ADDENDUM #1

**PROJECT: JAMES RIVER POWER STATION UPGRADE 2023-12-14
CITY UTILITIES OF SPRINGFIELD, MO**

DATE: 01/24/24

DATE	01/05/2024
PROJECT NUMBER	23.CU.001
DRAWN BY	JMC
CHECKED BY	JAL
SHEET NUMBER	E1

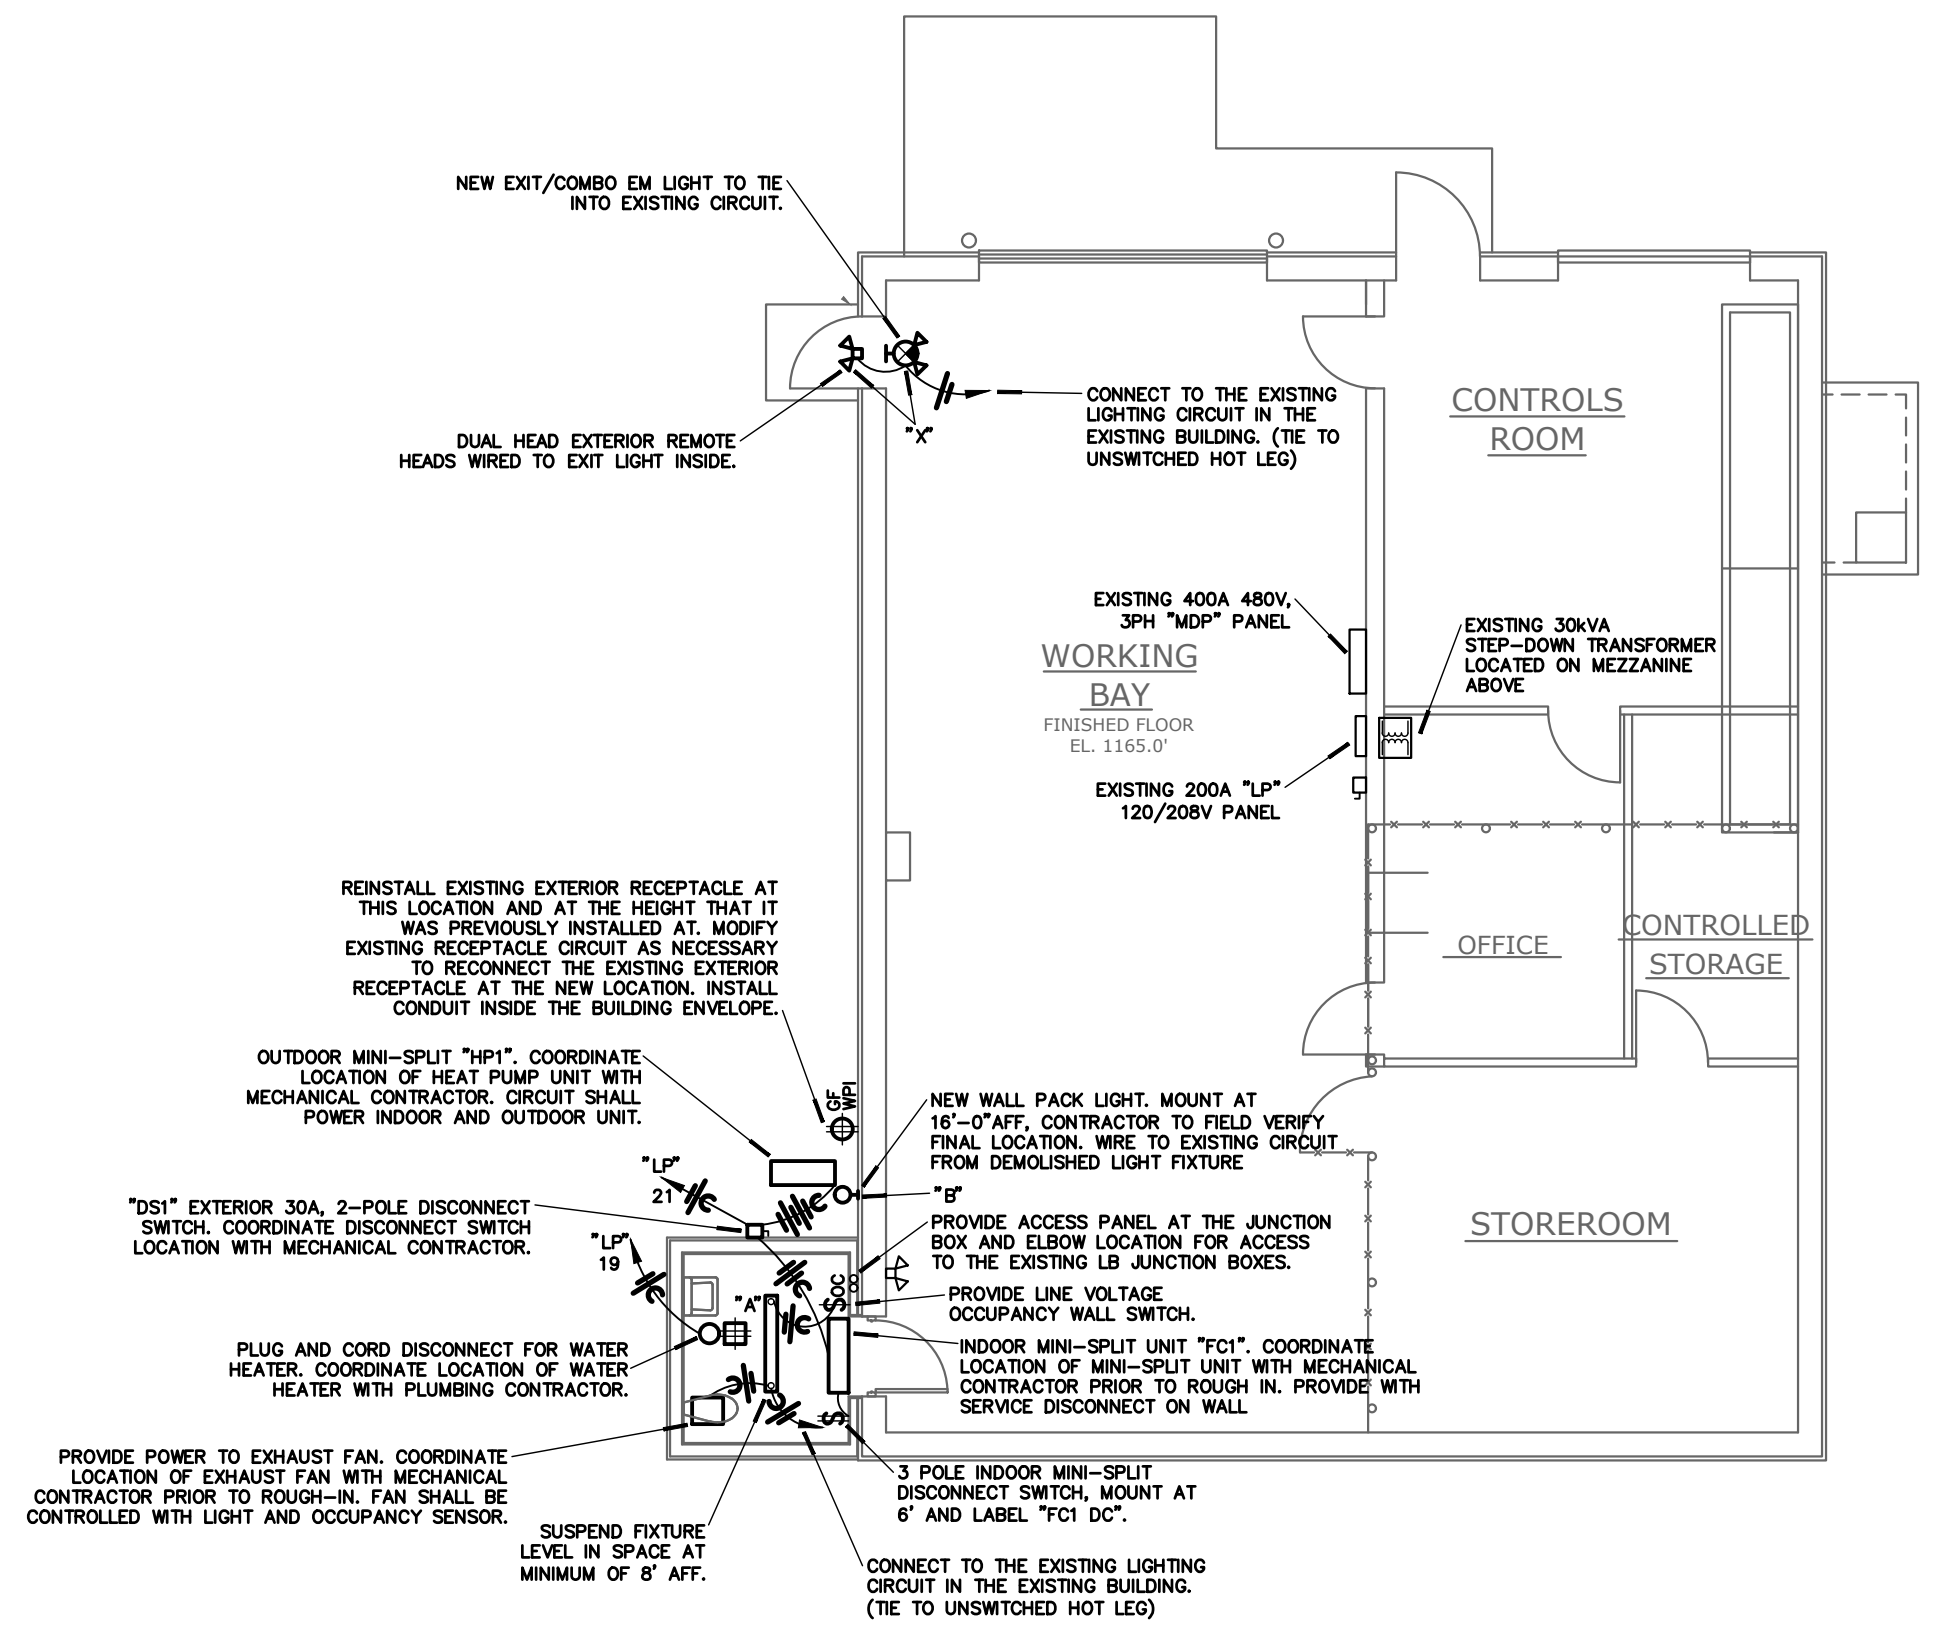
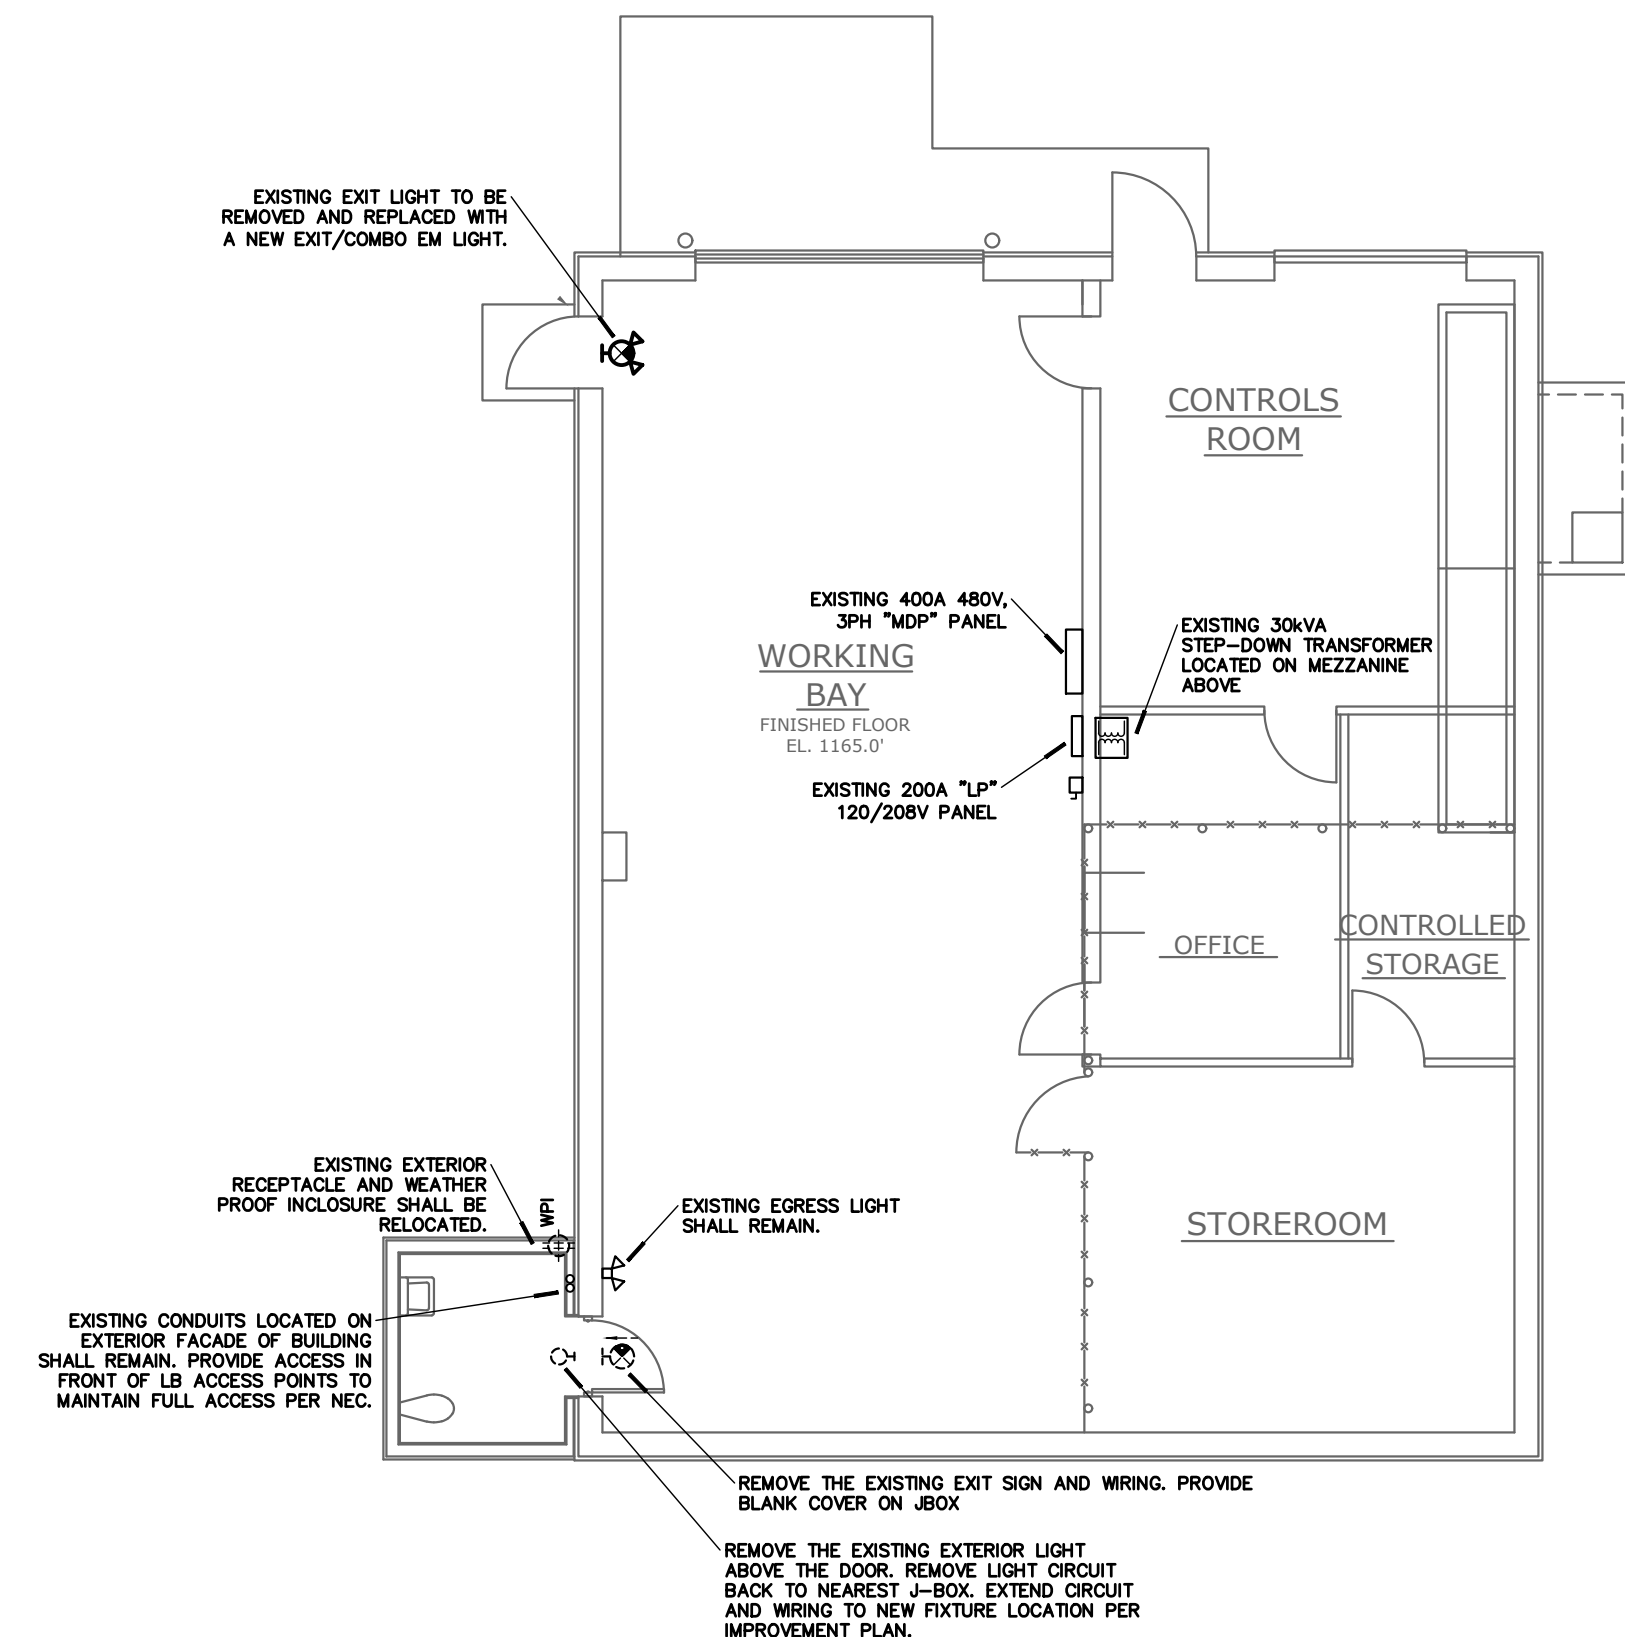
Reference E1, “Circuit Breaker Panelboard Schedule”:

1. Power for the backflow heat box was revised to be powered from panel “LP”. Provide new breaker as noted.
2. Provide conduit and wire for communication for meter and heated box per plans.
